# UNITED STATES PATENT AND TRADEMARK OFFICE

APPLICATION NO.	FILING DATE	FIRST NAMED INVENTOR	ATTORNEY DOCKET NO.	CONFIRMATION NO.
10/755,427	01/12/2004	Lee Bolduc	203-2626 DIV CON VIII (24)	9695
7590 Mark Farber, Esq. U.S. Surgical, A Division of Tyco Healthcare Group, LP 150 Glover Avenue Norwalk, CT 06856			EXAMINER YABUT, DIANE D	
			ART UNIT 3734	PAPER NUMBER
			MAIL DATE 08/24/2010	DELIVERY MODE PAPER

<b>Office Action Summary</b>	<b>Application No.</b> 10/755,427	<b>Applicant(s)</b> BOLDUC ET AL.	
	<b>Examiner</b> DIANE YABUT	<b>Art Unit</b> 3734

### DETAILED ACTION

**Figure 2, Miller**

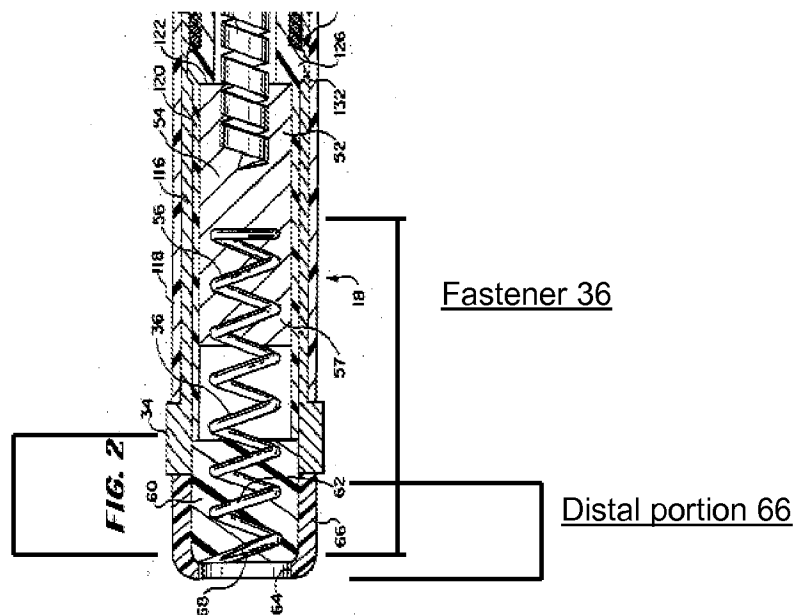
Claims 1, 4-6 and 19-30: Miller discloses an applicator comprising a distal portion having an elongate outer tube **66**, a connecting end and a terminal end, a proximal portion having a handle and an actuator **22**, the proximal portion being attached to the connecting end of the distal portion, and a rotator **60** cooperating with the actuator (as it facilitates advancement of a fastener), wherein a “rotator” is “a thing that causes something to rotate,” or guides and ejects through a helical path, the rotator including a longitudinal groove **62** extending along at least a portion thereof (at least one turn on rotator **60**), the groove configured to receive a portion of a fastener **36**, wherein the rotator resides within and extends substantially the length of the outer tube such that actuation of the actuator results in rotation and translation of the fastener relative to the outer tube while the rotator remains longitudinally or axially stationary with respect to the outer tube (Figures 1-3; col. 5, line 57 to col. 6, line 22). The applicator has a thread

form **62** (distal turns on rotator **60**) contained in an interior of the terminal end adapted to engage a plurality of fasteners wherein the thread form is an interlock spring fixedly retained in the interior of the terminal end, wherein “spring” is taken to mean an element that imparts an “actuating force.” A nose piece **54** is attached to a terminal end having a structure projecting perpendicular toward a longitudinal axis of the outer tube and may engage a plurality of fasteners. The longitudinal groove is adapted to slidably receive the portion of the fasteners, and at least a portion of the fasteners (proximal to the rotator **60**) surrounds the rotator, and the longitudinal groove being formed on an outer surface of the rotator (on the outer sides where the fastener **36** enters and exits the rotator).

Rotator 60 with longitudinal groove 62, wherein a rotator is “a thing that causes something to rotate”

12. Applicant also generally argues that the rotator **54** in Miller is not axially stationary and does not eject the fastener **36**. However, the cited rotator is **60**, or "fixed, fluid tight plug **60**" which stays axially stationary (col. 6, lines 8-13), and the fastener **36** "is rotated through passageway **62** in a screw like manner and exits the passageway through an opening **64** in an insulative tip member **66** fixed about the plug **60**" (col. 6, lines 14-22), and therefore Miller reads on these limitations.
